Blower motor switch wiring upgrade

M-371-002

(March 2008)

All CXU,CHU,GU Built Before Feb 1 2008

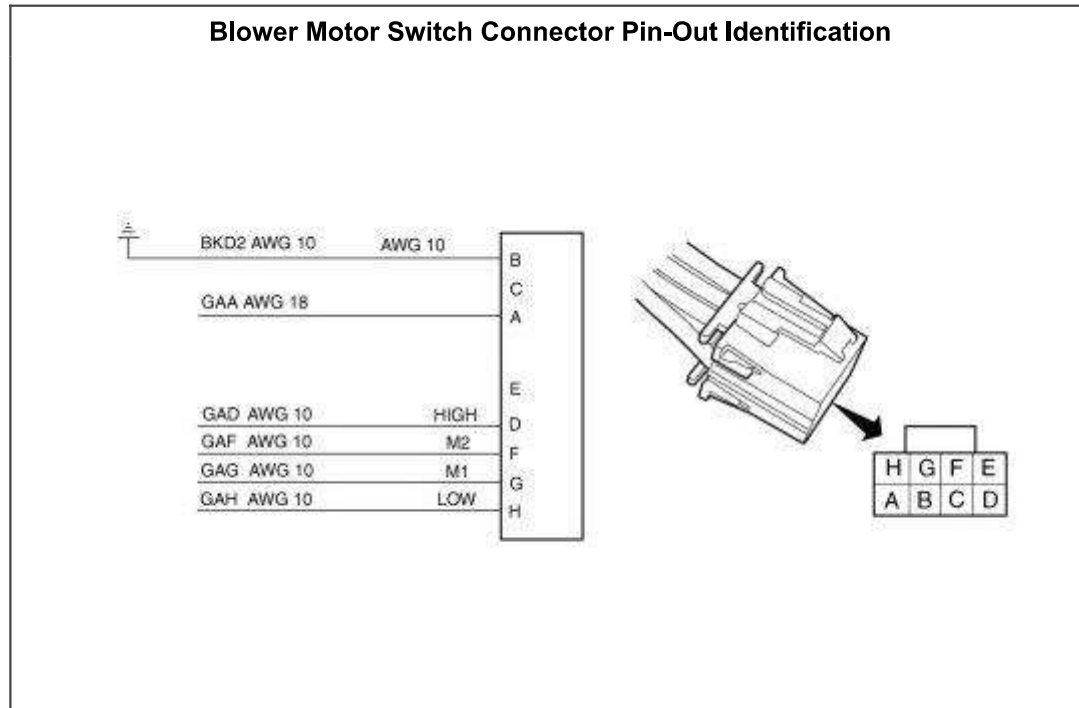
4. Using the proper terminal removal and crimping tools, individually remove each of the wires (with the exception of the black [or gray] wire labelled BKD2, and the white wire labelled GAD) from the connector body, cut the existing terminal from the wire, strip the insulation from end of the wire and then install new terminals (part number 7526–12015858 for 10 gauge wires, and part number 7526–12162595 for the single 18 gauge wire). Insert the wire into the correct cavity of the new connector body (part number 960AM18).

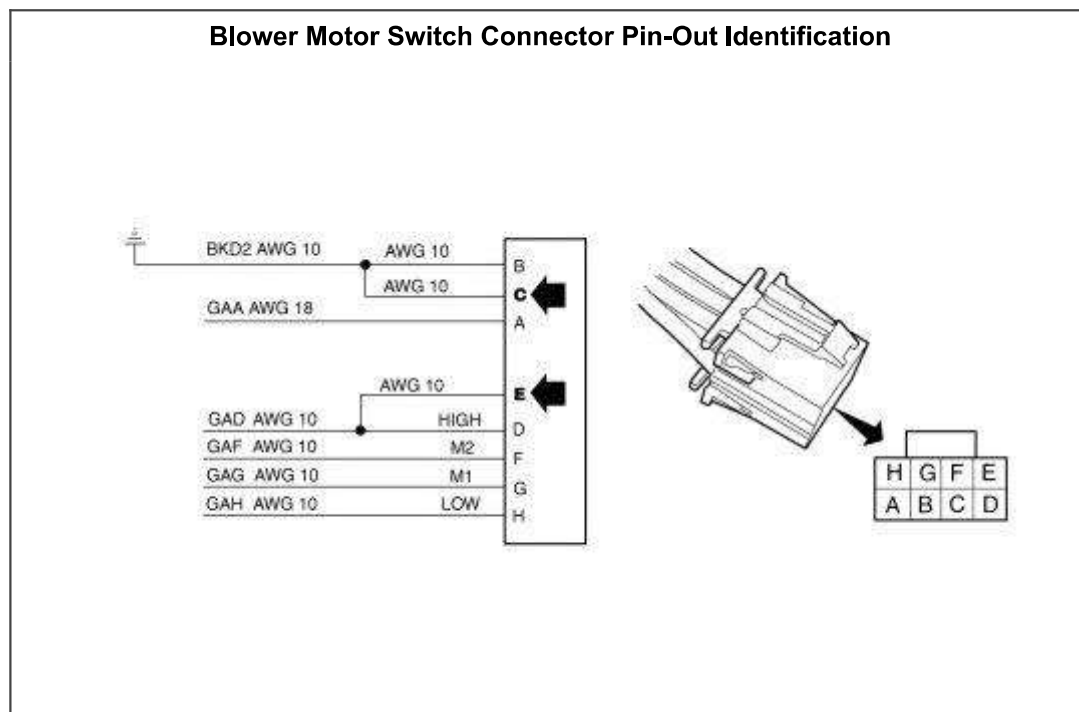
7. Cut each of the spliced wires to the same length as the existing BKD2 and GAD wires, and strip the insulation from the end of the wires and install new terminals (part number 7526-12015858).
8. Insert each of the wires into the appropriate connector body cavities as follows:

- Black (or gray) wire BKD2 — connector cavity B
 - BKD2 spliced wire — connector cavity C
 - White wire GAD — connector cavity D
 - GAD spliced wire — connector cavity E
9. Install two secondary locks (part number 7526-12064999).
 10. Reconnect the two connectors to the climate control panel, and then reinstall the climate control panel to the instrument panel.
 11. Reinstall the “D” panel.
